SCHWEIZER SERVICE INFORMATION NOTICE

NOTICE NO. N-145

SUBJECT: REPLACEMENT OF 269A8244 OR 269A8244-7 TAILBOOM CLAMP ASSEMBLY FOR MUFFLER/RESONATOR KIT INSTALLATION 269A8245 OR RESONATOR KIT INSTALLATION 269A8245-3

MODELS AFFECTED: All Model 269C Helicopters equipped with subject Muffler/Resonator Kit or Resonator Kit Installation

Figure 1. Replacement of muffler/resonator tailboom clamp assembly

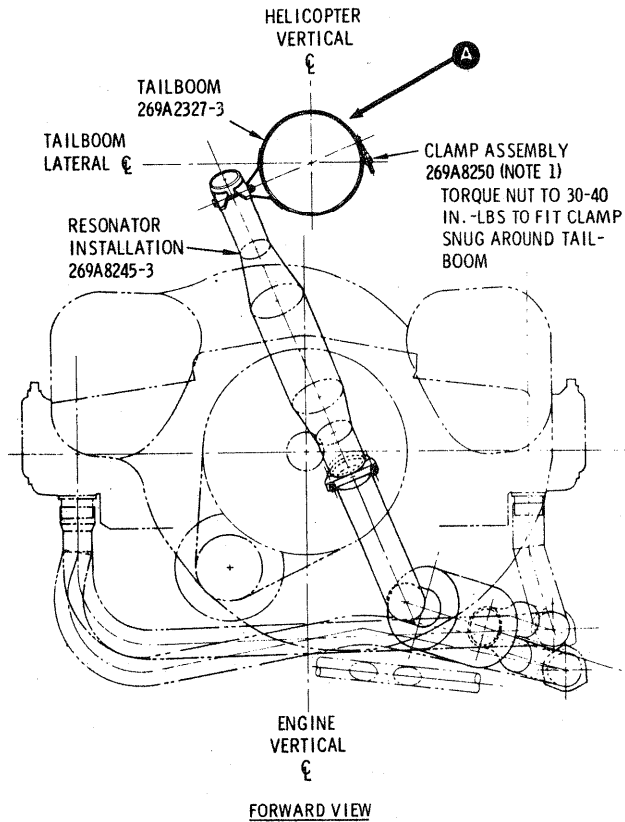
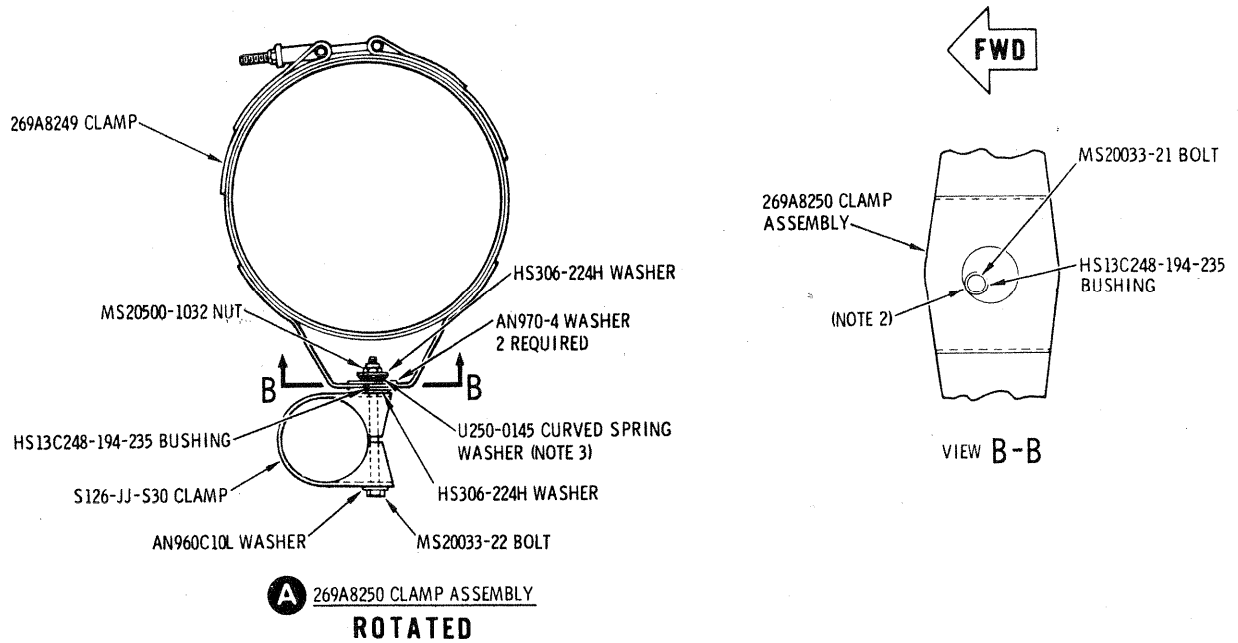
PREFACE: The information given in this Service Information Notice lists a procedure for field replacement of the 269A8244 or 269A8244-7 tailboom clamp assembly with an improved 269A8250 clamp assembly. The new 269A8250 clamp assembly incorporates a 269A8249 clamp made of thicker sheet metal and having a larger flange on the stand-off bracket for greater distribution of loads from the bracket to the clamp. New attach hardware, together with a larger diameter mounting hole in the stand-off bracket, also allows for movement during thermal expansion and thus prevents cracking or damage to the stand-off bracket.

b. Install new 269A8249 clamp on tailboom; torque nut 30 to 40 inch-pounds so that clamp fits snug around tailboom. (See Figure 1.)

c. Position S126JJ-S30 clamp on resonator; install clamp to stand-off bracket with hardware as shown. (See Figure 1, Detail A.)

Ensure that bolt/bushing combination is installed in lower forward quadrant of stand-off bracket mounting hole (engine cold) to allow for movement during thermal expansion. (See Figure 1, Section B-B.)

1. 269A8250 CLAMP ASSEMBLY REPLACES EXISTING 269A8244 OR 269A8244-7 CLAMP ASSEMBLY.
2. INSTALL BOLT/BUSHING COMBINATION IN LOWER FORWARD QUADRANT OF MOUNTING HOLE (ENGINE COLD) TO ALLOW FOR MOVEMENT DURING THERMAL EXPANSION.
3. INSTALL AS SHOWN.
